## Cambridge City Council

### DEVELOPMENT PLAN SCRUTINY SUB-COMMITTEE

**6      Mill Road Depot Draft Planning and Development Brief** *(Pages 43 - 272)*

Fig 14 Existing land uses

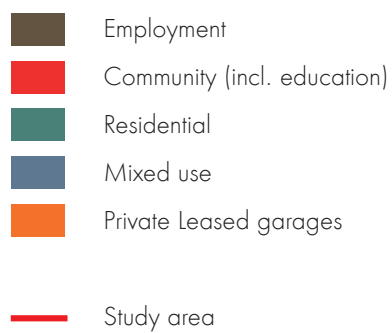
Representation(s)		Nature	Appearance	Soundness Tests
31067	Historic England (Mrs Debbie Mack) [5828]	Object	Not Specified	None
<p><i>Summary:</i></p> <p>Figure 14 - We would suggest that the orange garages are added to the legend.</p>

<i>Action</i>		Add an orange box to the legend of Figure 14 with the text, 'Private Leased Garages'.		
---------------	--	---	--	--

19	<del>2.2.14</del> <u>2.2.15</u>	No other change
20	Fig 14	<p><i>Added an orange box to the legend with the following text:</i></p> <p>'Private Leased Garages'</p>
21	<del>2.2.15</del> <u>2.2.16</u>	No other change
22	Fig 15	<i>Amended figure to include proposed future foot/cycle bridge connection</i>

**Fig 27** Site Framework plan

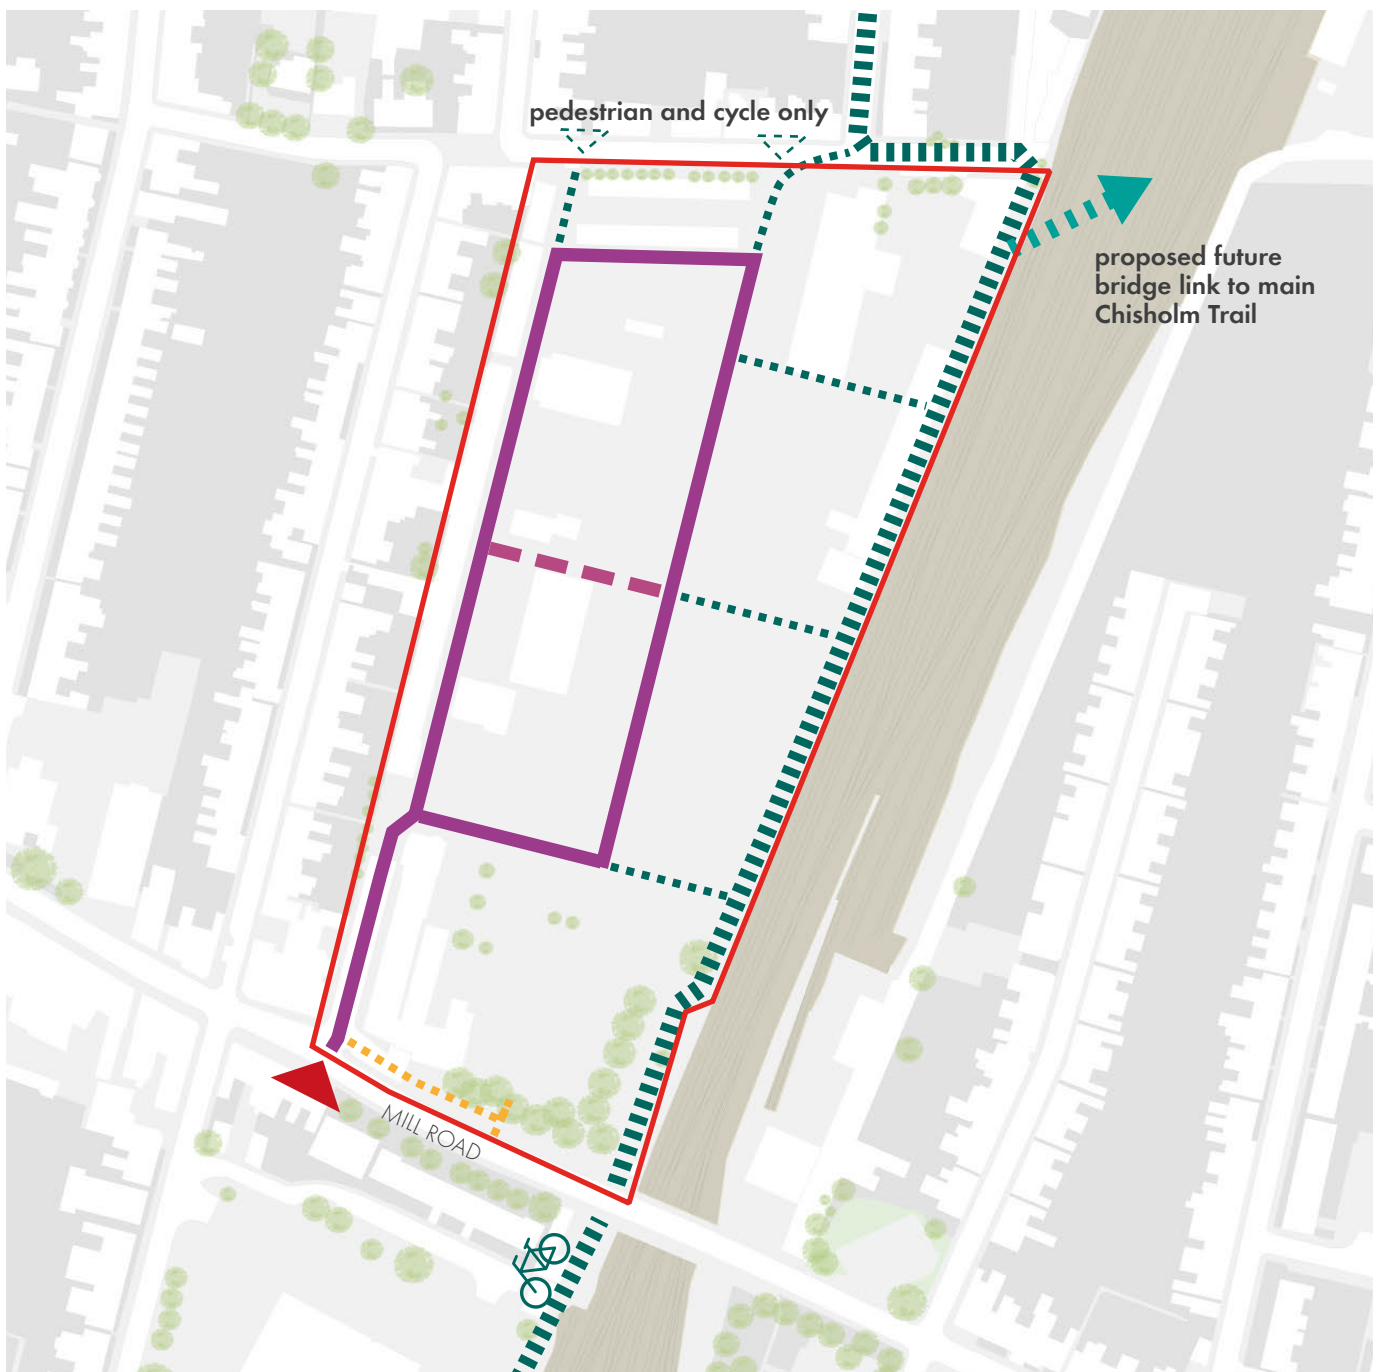
4.2.1	<ul style="list-style-type: none"> <li>• Support - The development of the depot site provides a valuable opportunity to provide the Chisholm Trail to the station. Site Framework Plan (Fig 27) shows the route which is likely to become heavily used with many bikes passing at speed. As such it should not cut through the depot site where it would endanger pedestrians, especially children.</li> </ul>
Figure 27 – Site Framework Plan	<ul style="list-style-type: none"> <li>• Support</li> </ul>

The development of the depot site provides a valuable opportunity to provide a major off-road cycle path to the station from north Petersfield and further away in that direction - as proposed by Jim Chisholm. Site Framework Plan (Fig 27) shows the route he outlined running along beside the railway and part of Hooper St. This cycle route is likely to become heavily used with many bikes passing along it at speed as they do on other dedicated off-road routes. As such it must be recognised that it should not cut through the depot site where it would endanger pedestrians, especially children.

Representation(s)		Nature	Appearance	Soundness Tests
31169	Cllr Richard Robertson [5835]	Support	Not Specified	None
<b>Summary:</b> I support the overall layout as shown in the Site Framework Plan (Fig 27) which I believe reflects well the views expressed in the consultation.				
<b>Response</b>  Comments duly noted. The alignment of the trail as it runs around the site and the local links has been the subject of further discussions with the county council and resulted in potential amendments to both the main route and internal links as shown on the proposed revisions to Figure 28.  Furthermore the direct route across Hooper Street from Ainsworth Street to the site, shown in figure 43, has been removed.				
<b>Action</b>  Amend Figure 28 Transport and Access to show possible changes to the Chisholm Trail route and revisions to local links and Figure 27 - Site Framework Plan. This includes a proposed new bridge over the railway line to potentially form the alignment of the main Chisholm Trail.  Amend figure 27 and 28 as follows to:  Include the proposed future foot/cycle bridge connection  Link the planned Chisholm Trail route on Ainsworth Street to the local site network  Close proposed through route to Chisholm Trail alongside Mill Road Bridge  Amend figure 43 as follows to:  Remove direct link across Hooper Street from Ainsworth Street to the site

Amend Figure 28 Transport and Access to show possible changes to the Chisholm Trail route and revisions to local links and Figure 27 - Site Framework Plan. This includes a proposed new bridge over the railway line to potentially form the alignment of the main Chisholm Trail.

Amend figure 27 and 28 as follows to:

**Fig 43** Illustrative plan - This is an illustrative plan which indicates how the framework and parameter diagrams could be applied - existing access arrangements apply as set out in para 4.3.12

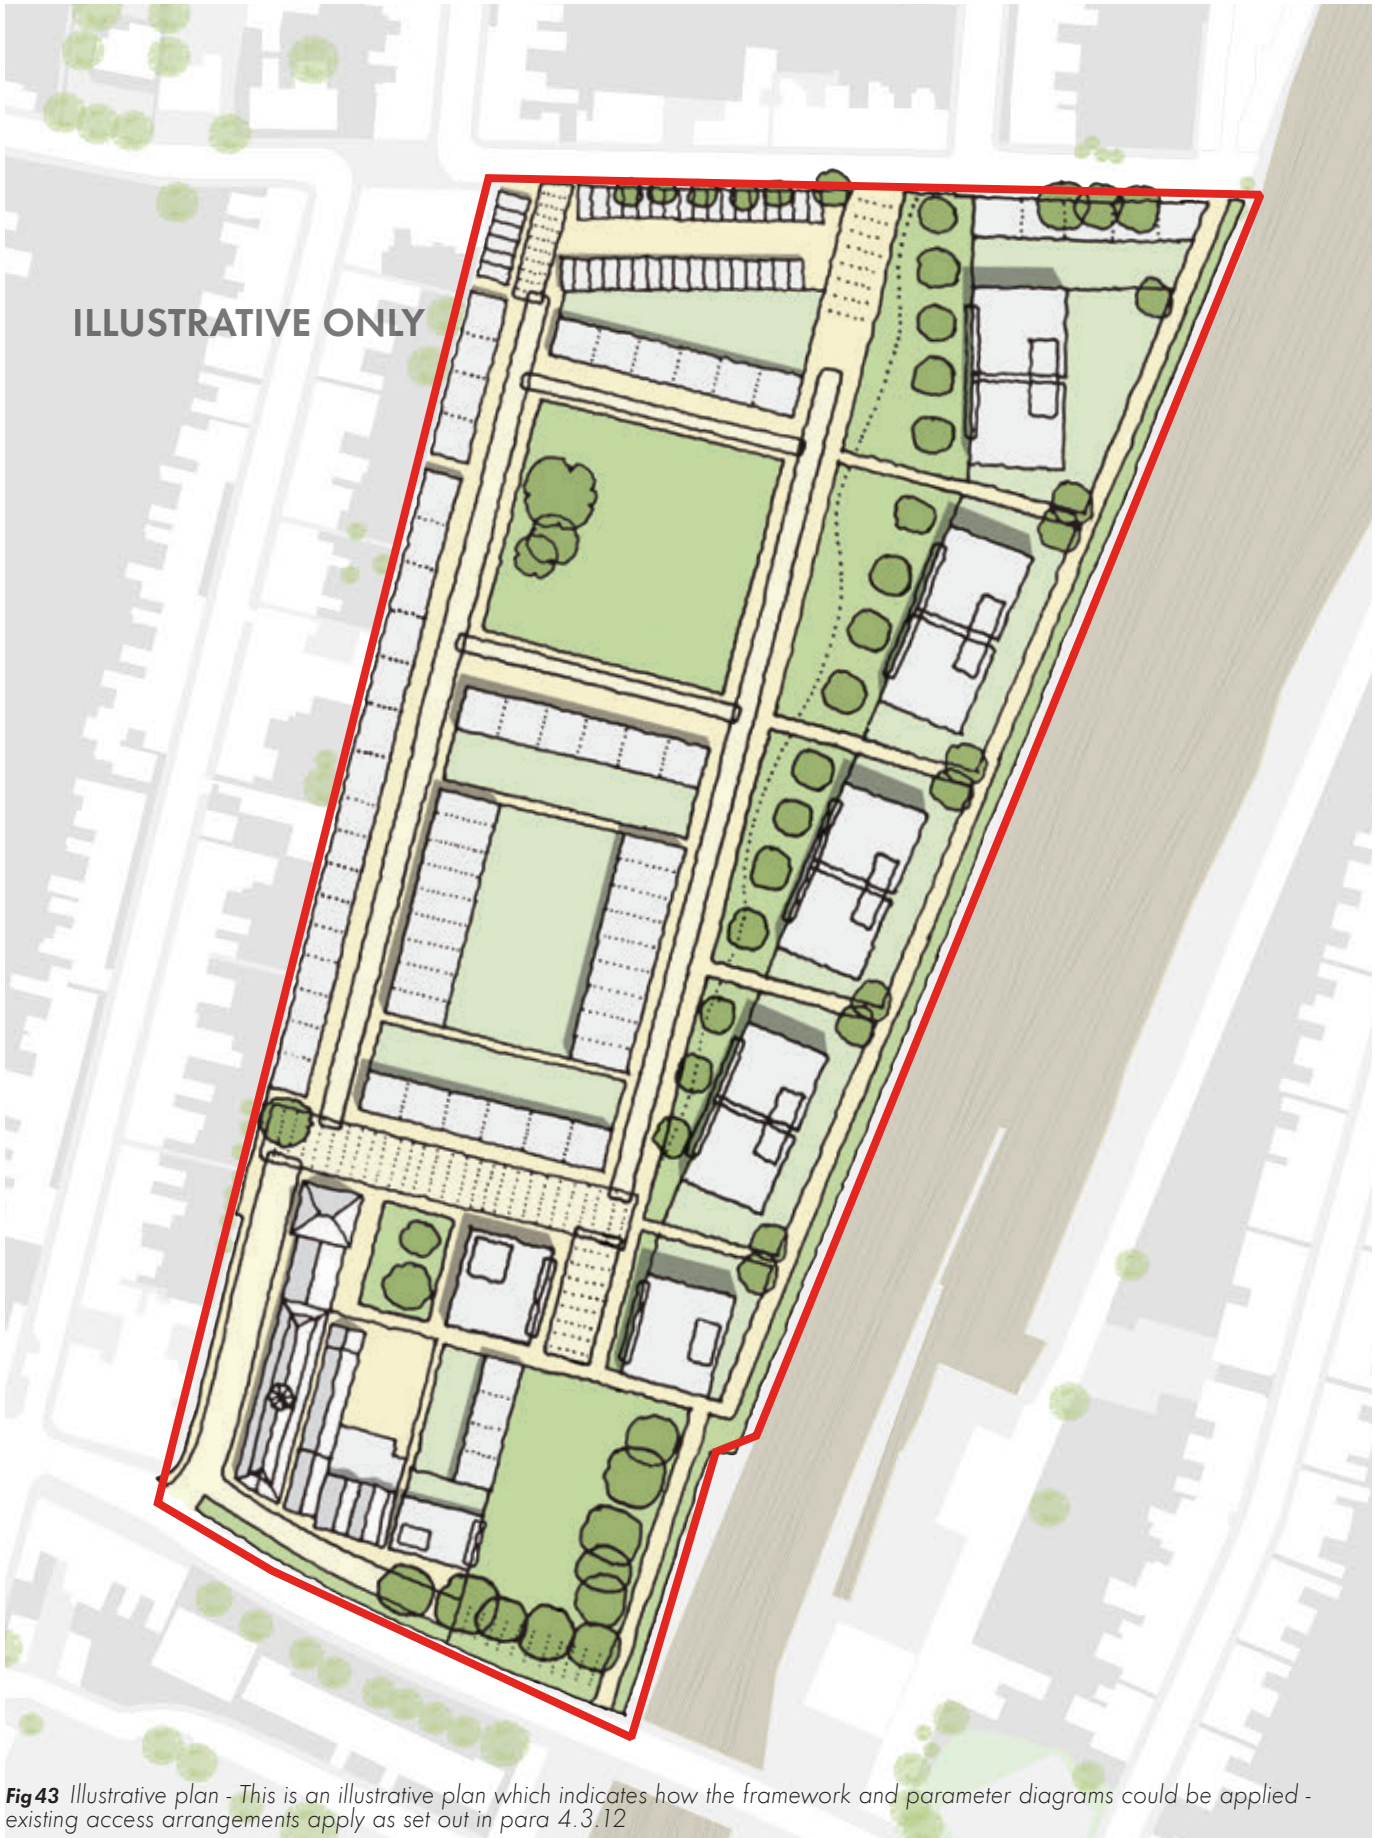
Representation(s)		Nature	Appearance	Soundness Tests
31058	Cambridge Association of Architects (Mr David Adams) [4949]	Object	Not Specified	None
<b>Summary:</b> Orientation (front/back) should be clearly highlighted on the illustrative plan - in order to avoid creating enclosed courtyards giving their back to the street - as might happen around 'Mill Park' (and not be mistaken with the &quot;colleges inspired&quot; inward looking residential courts)				
<b>Response</b>  The illustrative layout as shown in Figure 43 clearly shows the demarcation of rear gardens for houses and green space surrounding flatted buildings. It is not considered necessary, at this stage, to be overly prescriptive in order to enable some flexibility of house type and orientation.				
<b>Action</b>  No action.

Furthermore the direct route across Hooper Street from Ainsworth Street to the site, shown in figure 43, has been removed.

Amend figure 43 as follows to:

55	<del>4.6.10</del> <u>4.6.11</u>	No other change
56	Fig 43	<p><i>Amend figure as follows to:</i></p> <p><i>Remove direct link across Hooper Street from Ainsworth Street to the site</i></p> <p><i>Close proposed through route to Chisholm Trail alongside Mill Road Bridge</i></p>
